Subject: VIRGIL C. SUMMER NUCLEAR STATION (VCSNS)
DOCKET NO. 50/395
OPERATING LICENSE NO. NPF-12
RESPONSE TO REQUEST FOR ADDITIONAL INFORMATION
REGARDING REQUEST TO USE ALTERNATIVES TO ASME BOILER
AND PRESSURE VESSEL CODE, SECTION XI, RELIEF REQUEST
RR-II-08 (0-C-02-3202)

**South Carolina Electric & Gas Company (SCE&G)
Virgil C. Summer Nuclear Station (VCSNS)
Response to NRC Request for Additional Information (RAI)
Regarding Inservice Inspection Relief Request
RR-II-08**

CGE-1-3100

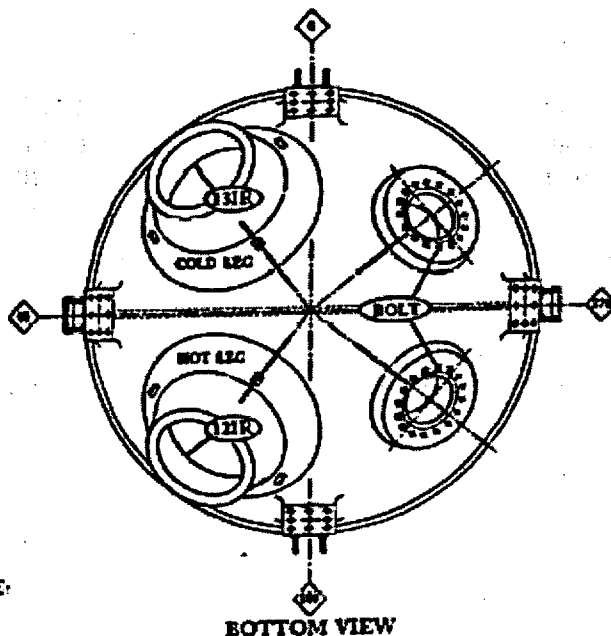
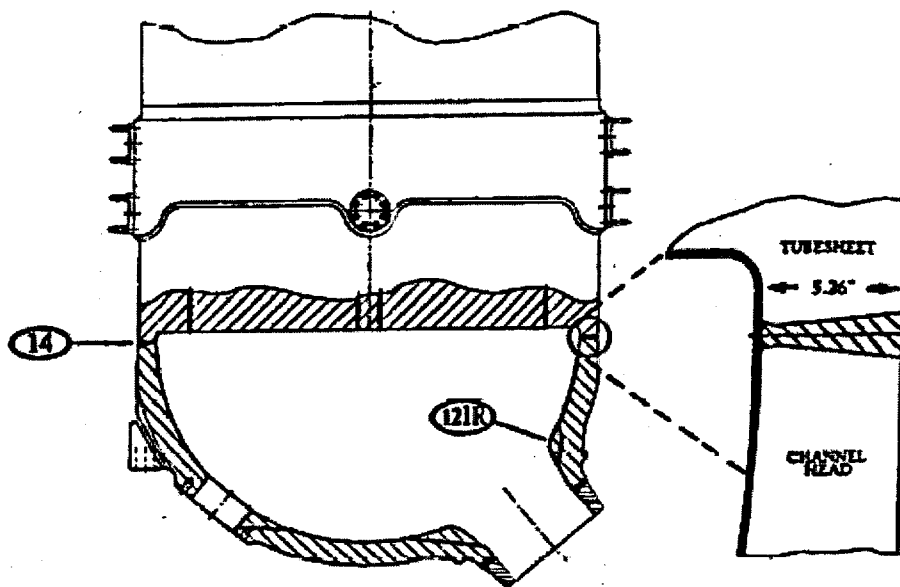
- b. The drawings (or pictorial discussion) showing the type and location of interferences with the Code-required ultrasonic examination. The drawing number was provided in the submittal but not the drawing itself. Identify the percent coverage that is able to be achieved on these nozzles using Code-required ultrasonic examinations.**

The drawing and the Preservice data are attached for reference.

The ultrasonic examinations performed for the detection of corner flaws per IWB-2500-7(d) consists of two circumferential scans, one clockwise and one counterclockwise. Both exams are performed with a specially designed 28 degree longitudinal wave alternative style transducer. This examination technique has scan interferences from manufacturing pads and the internally fabricated primary head drain hole. The combination of these interferences has limited the maximum achievable coverage to 80.4 per-cent of the examination volume.
